FFC at Cloverleaf Center: Site Plan Amendment No. 81998006F

FFC at Cloverleaf Center: Site Plan Amendment No. 81998006F: Amendment to add a 1,584 sf second floor addition, add a roof structure above the Wing #2 loading dock, add concertina wire to the top of the fence in the rear of the property, and request a parking waiver; located in the southwest quadrant of the intersection of Interstate 270 and Father Hurley Boulevard, off of Century Boulevard; 13.41 acres; CR 2.0, C-1.25, R-1.0, H-145T and Germantown Transit Mixed Use Overlay Zone but reviewed under previous TMX-2 Zone; 2009 Germantown Employment Area Sector Plan.

Recommendation – Approval with conditions

Figure 3: Addition Above Wing #2 Shown in Red

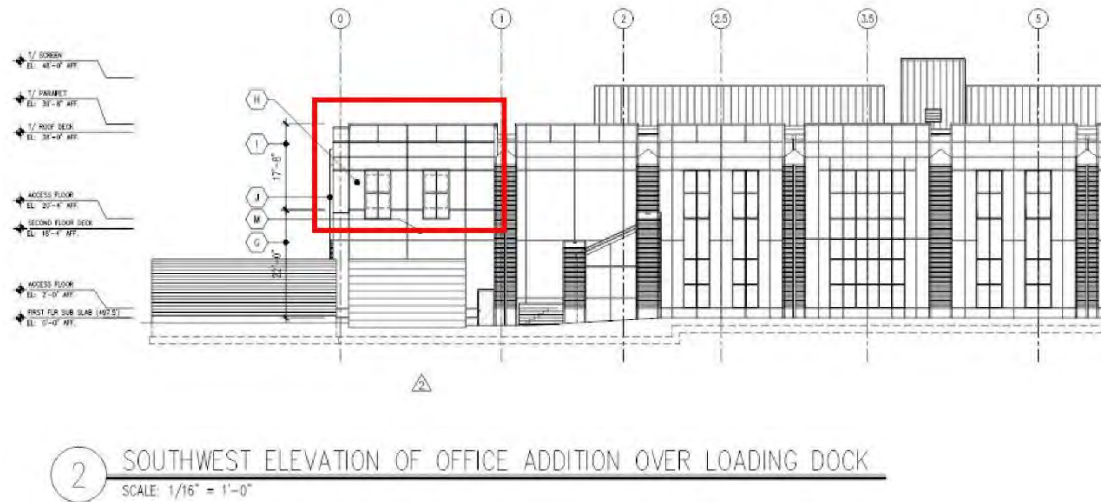
The Amendment also adds a roof structure over the Wing #2 loading dock area that results in additional columns beyond the footprint of the original building. The Applicant has demonstrated that these additional columns will not impact pedestrian or vehicular circulation.

The proposed minor additions will be compatible with the adjacent and confronting uses, as well as adjacent approved development plans (Century). The proposed building additions allow for a minor expansion of the existing use and continue the same building façade treatment as the remainder of the building (Figure 3). Additionally, the building has very limited visibility from Century Boulevard, which was intentionally obstructed with berms, landscaping, and a large setback from all property boundaries. Therefore, the proposed additions will also have limited visibility from surrounding roads or properties.
